CITY OF ALBUQUERQUE

Re: Mata Auto Garage 142 40th St SW 30-Day Temporary Certificate of Occupancy Transportation Development Final Inspection Architect's Stamp dated 03-03-23 (K12-D037) Certification dated 12-19-24

TRAFFIC CERTIFICATION

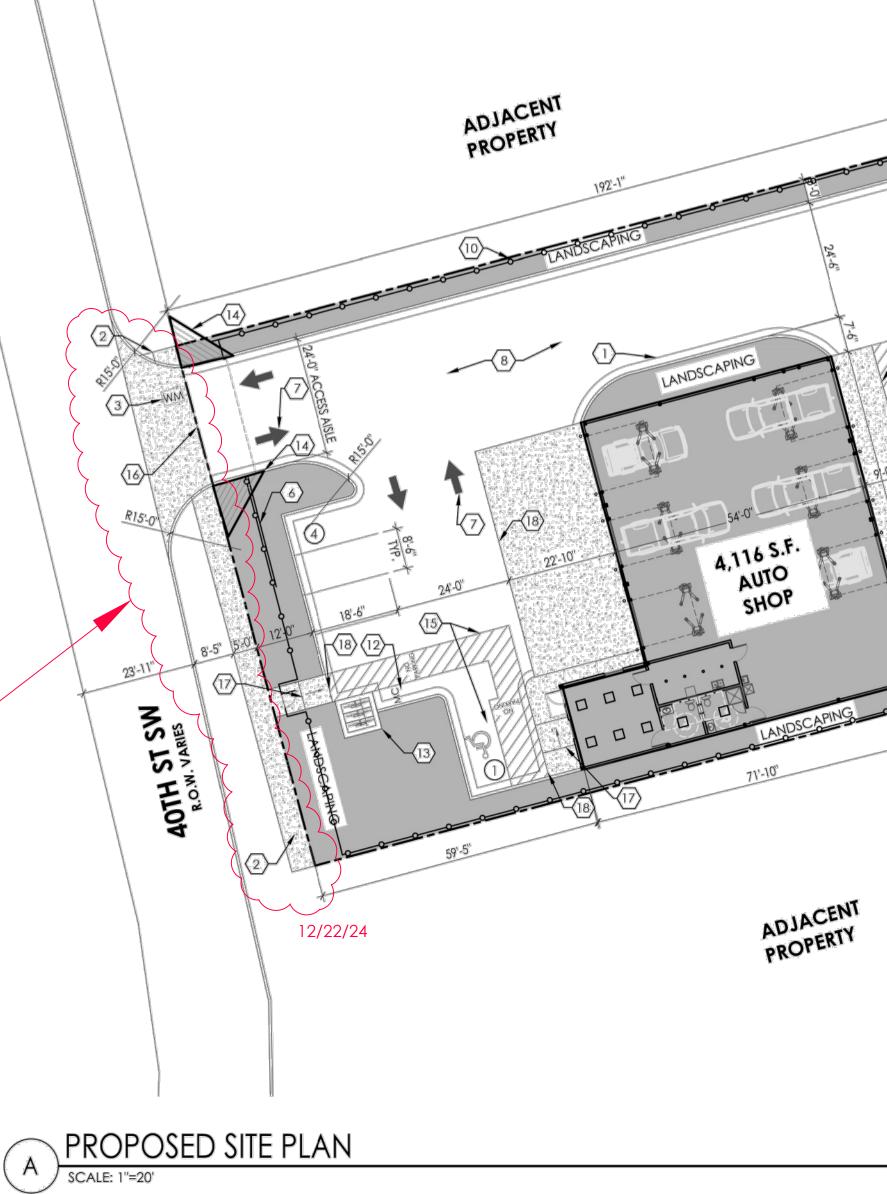
• Per city requirement and approved site plan, a concrete site access must be constructed up to the property line. The current gravel site access may damage the asphalt edge within the city right of way.

- The ADA accessible parking sign must have the required language per 66-7-352.4C NMSA 1978 "Violators Are Subject to a Fine and/or Towing." Please call out detail and location of signs.
- The ADA access aisles shall have the words "NO PARKING" in capital letters, each of which shall be at least one foot high and at least two inches wide, placed at the rear of the parking space so as to be close to where an adjacent vehicle's rear tire would be placed. (66-1-4.1.B NMSA 1978)

• Per previous emails, the construction of the sidewalk and curb and gutter will be postponed until the adjacent south east property begins constructing their sidewalk and curb and gutter.

CONSTRUCTION OF THE SIDEWALK AND CURB AND GUTTER WILL BE POSTPONED UNTIL THE ADJACENT SOUTH EAST PROPERTY BEGINS CONSTRUCTING THEIR SIDEWALK AND CURB AND GUTTER TO ENSURE PROPER ALIGNMENT.

PER EMAIL FROM MARWA G. AL-NAJJAR WITH CABQ TRAFFIC ENGINEERING DATED DEC 16, 2024
